Project: TWICKENHAM STADIUM EAST STAND EXTENSION

Drawing title: LEVEL 2A PROPOSED GA PLAN

Doc ref	Project number	Drawing number	Revision
100-KSS-DR	15735	112	P03

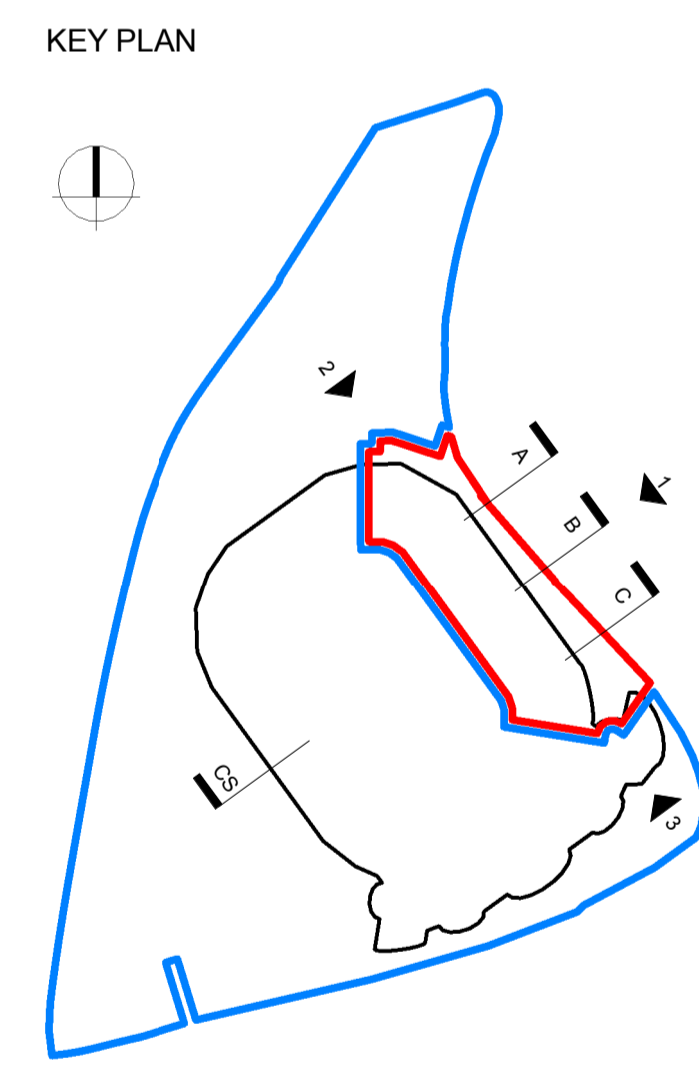
Revision Notes		
<b>PLANNING AMENDMENTS</b>		
A	GENERAL AMENDMENTS TO THE SOUTH END. INCREASED SHINGLES CLADDING AREA AND CURTAIN WALL REDUCED ACCORDINGLY.	AE PY
A1	REDUCED MASSING AND REVISED INTERFACE WITH THE SOUTH STAND.	KI PY
B	PPC LOUVRES LOCATED TO THE BOWL SIDE HAVE BEEN OMITTED.	NH LP
C	CURTAIN WALL SETTING OUT REVISED GENERALLY. SILICONE JOINTS TO TRANSOMS AND MULLION REPLACED WITH CAPPED SYSTEM. LEVEL 04 PPC LOUVRES SETTING OUT & HEIGHT REVISED. MONORAIL FOR ABSEILING REMOVED.	
D	GENERAL AMENDMENTS TO THE CENTRAL ELEVATION CANOPY AT LEVEL SA REVISED GENERALLY AND STANDING SEAM REPLACED WITH SINGLE PLY MEMBRANE. SUPPORT COLUMNS TO ROOF CANOPY REVISED. SQUARE FASCIA TO ROOF EDGE.	
D1	LEVEL SA GLAZED SCREEN EXTENDED IN HEIGHT AND PPC LOUVRES INCLUDED AT LOW LEVEL.	
D2	INCREASED SHINGLES CLADDING AREA AND CURTAIN WALL AREA REDUCED ACCORDINGLY. FOUR VERTICAL FINNS REMOVED.	
D3	PORCELAIN PANELS WITH SLOTTED HOLES FOR VENTILATION REPLACED WITH PPC LOUVRES. EXPRESSED HORIZONTAL PATTERN TO PORCELAIN PANELS OMITTED.

E	GENERAL AMENDMENTS TO THE NORTH END PORCELAIN CLADDING REPLACED WITH PPC ALUMINIUM CLADDING.	
E1	GREEN WALL TO THE NORTH END EXTENDED AND PPC LOUVRES REMOVED.	
E2	INCREASED SHINGLES CLADDING AREA AND CURTAIN WALL REDUCED ACCORDINGLY.	
E3	FENCELINE, GATE AND PERIMETER COLUMNS SETTING OUT REVISED.	
F	CANOPY TO TURNSTILES REVISED.	
F1	PORCELAIN PATTERN CHANGED FROM HORIZONTAL TO VERTICAL.	
G	PORCELAIN PANELS TO THE SOFFIT OF THE ARCH REPLACED WITH PPC ALUMINIUM PANELS. PORCELAIN PANELS SETTING OUT REVISED.	
H	ROOF TO LEVEL SA (NORTH END) EXTENDED.	
K	GLAZED SPANDREL PANELS REPLACED WITH METAL SPANDREL PANEL. PORCELAIN PANELS REPLACED WITH PPC ALUMINIUM CLADDING.	
L	PPC LOUVRES INCLUDED FOR MECHANICAL VENTILATION.	
L1
